Access Compliance Report

Public Rights-of-Way

(Curb Ramps)

Intersection ID: 53624	Main Street: PROSPERITY RIDGE RD	Cross Street: RIDGE RD	Location: SW
ADA ID: FDC5691EA704	Ramp Type: Perp	Initial Pass/Fail: Fail	Overall Compliance: No
Severity Score: 33.75			
Codes/Mitigation Info/Possible Solution		Field Measurements/Component Compliance

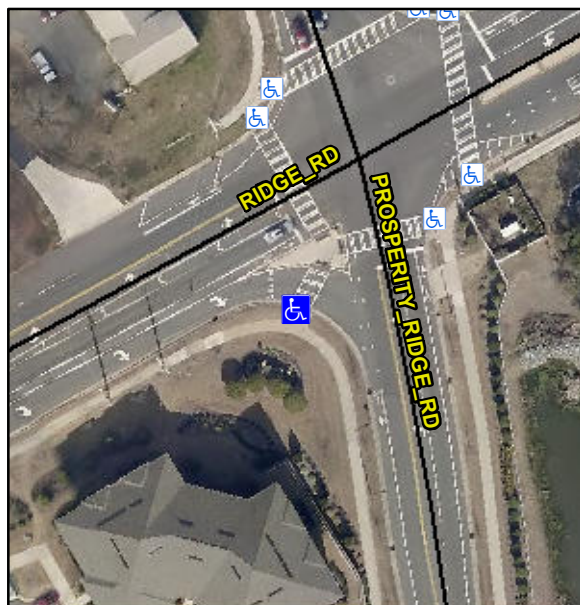
R304.5.1, R304.2.2, R304.5.3

Compliance	Description	Data	Compliance	Description	Data
N/A	Ramp Length (in)	96.0	No	Ramp Slope (%)	8.8
No	Ramp Width (in)	47.5	No	Ramp XSlope (%)	5.1
N/A	Flare Type LT	N/A	N/A	Flare Type RT	N/A
N/A	Flare Slope LT (%)	N/A	N/A	Flare Slope RT (%)	N/A
N/A	Flare Traversable LT?	N/A	N/A	Flare Traversable RT?	N/A
N/A	Landing Length (in)	N/A	N/A	DWS Provided?	N/A
N/A	Landing Width (in)	N/A	N/A	DWS Contrast?	N/A
N/A	Landing Slope (%)	N/A	N/A	DWS Length (in)	N/A
N/A	Landing X Slope (%)	N/A	N/A	DWS Full Width?	N/A
N/A	Landing Curb? (Y/N)	N/A	N/A	DWS Offset (in)	N/A
N/A	Shared Landing?	N/A			
N/A	Gutter Ponding?	N/A	N/A	Gutter Slope (%)	N/A
N/A	Gutter Lip Ht (in)	N/A	N/A	Gutter X Slope (%)	N/A
N/A	Painted X Walk1?	Yes	N/A	Painted X Walk2?	N/A
	X Walk 1 Direction	To NE		X Walk 2 Direction	N/A
N/A	X Walk 1 Width (in)	113.0	N/A	X Walk 2 Width (in)	N/A
	X Walk 1 Slope (%)	3.0		X Walk 2 Slope (%)	N/A
	X Walk 1 X Slope (%)	2.9		X Walk 2 X Slope (%)	N/A

Remove & Replace Entire Ramp.
